RE: Bendigo Ophir Project
Air Quality Assessment Review

Table 1: ORC Information Requests, PDP and SLR Responses

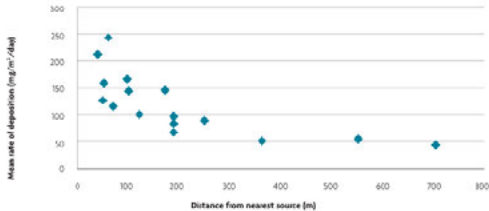
5	<p>Please provide justification for the use of 7.5 m/s windspeeds in the qualitative assessment of dust impacts, when 5.5 m/s is recommended by IAQM (2016) Method or < 5 m/s is discussed in the MfE Good Practice Guide for Assessing and Managing Dust. Your answer should include discussion on mechanically generated dust from vehicle activity (rather than from only wind-blown dust) and should also explain why PDP</p>	<p>PDP considers that the AQA adequately assesses the actual and potential adverse effects of dust, including that generated by vehicle movements. The AQA applies IAQM's Source-Pathway-Receptor framework to assess dust risks, including consideration of local meteorology and receptor distances.</p> <p>IAQM (2016) does not prescribe operational triggers; professional judgement is expected to determine site-specific wind-speed trigger levels. The 5.5 m/s wind-speed figure quoted by SLR Review is only described by the IAQM guidance as 'sometimes used as a general threshold' and states that instead of this general threshold 'it is preferable to use a wind blow initiation wind speed specific to the mineral type.'</p>	<p>The AQA stated that the GPG Dust "suggest that high-risk conditions occur when windspeeds are over 7.5 m/s". The GPG Dust never mentions this wind speed. Further in Section 7.2 the 7.5 m/s is introduced as high-risk conditions for dust generation ("dust pick up begins..."). Then in Section 7.3.4 the high wind speed travel distances are mismatched in the text stating 7.5 m/s in the second dot point (at the top of page 52) whilst presenting 10 m/s in Figure 17. Further Figure 17 compares travel distance rather than dust generation speeds).</p>

#	ORC Request	PDP Response	SLR Response
	<p>only consider high-risk winds of greater than 7.5 m/s are capable of affecting Dwelling 3.</p>	<p>Section 7.3.4 of the AQA utilises Stoke's Law of particle dynamics to estimate that wind-speeds of 5 m/s may transport dust particles (specific to the density of BOGP mine materials) up to 75 m from source, and higher wind-speeds of 7.5 m/s are required to transport these dust particles up to 150 m.</p> <p>Given that the nearest sensitive receptor to dust sources (Dwelling 3) is located approximately 140 m from the BOGP project boundary (and significantly further from construction or operational phase dust sources), only winds greater than 7.5 m/s may present a plausible transport pathway for this receptor given the site-specific density of dust particles.</p> <p>The GPG:Dust also supports site-specific triggers and limiting or ceasing dusty activities on "particularly windy days". The GPG:Dust recommends a wind-speed warning of 10 m/s (1 minute average, occurring twice in 20 minutes) as a suggested trigger level.</p> <p>Section 9.3.2 and Table 23 of the AQMP detail that a two-level trigger alert for 1-hour average wind-speeds will be implemented at BOGP as a dust mitigation measure:</p> <ul style="list-style-type: none"> • Tier 1 trigger (alert to staff for enhanced vigilance of dust): 5 m/s, 1-hour average • Tier 2 trigger (alert to staff to observe dust generating activities and mitigation measures. Cease processes if dust witnessed as crossing the BOGP boundary): 7.5 m/s, 1-hour average. 	<p>For most sources on site this does not impact the assessment, due to the significant distances between sources and receptors. For Dwelling 3, characterised as both an intermediate distance receptor (140 m, Table 33) and a close receptor (100 m, Table 38) in different sections of the AQA, the use of 7.5 m/s has potential implications for the frequency of impacts from the haul road to the entry point of Shepherds Valley (given 53.4% of winds blow in that direction).</p> <p>Rereading the AQA and the PDP response highlights that this receptor should be considered an intermediate distance receptor (140 m). Therefore, putting aside the confusion generated by the multiple designations of the receptor, the use of 7.5 m/s over other published data comes down to professional judgement. Reflecting on PDP's responses and clarification of their position around the purpose of the use of 7.5 m/s, and given the professional experience of the author and reviewers, the use of 7.5 m/s can be accepted in the context as a plausible transport pathway for an intermediate distance receptor.</p> <p>Additionally, SLR has reviewed external data (Bluett et. al. 2015¹) that supports PDP's position based on the likely distance of impact from haul roads to receptors. While the data reviewed was from an unfinished study the data supports limited impacts from a haul road.</p>
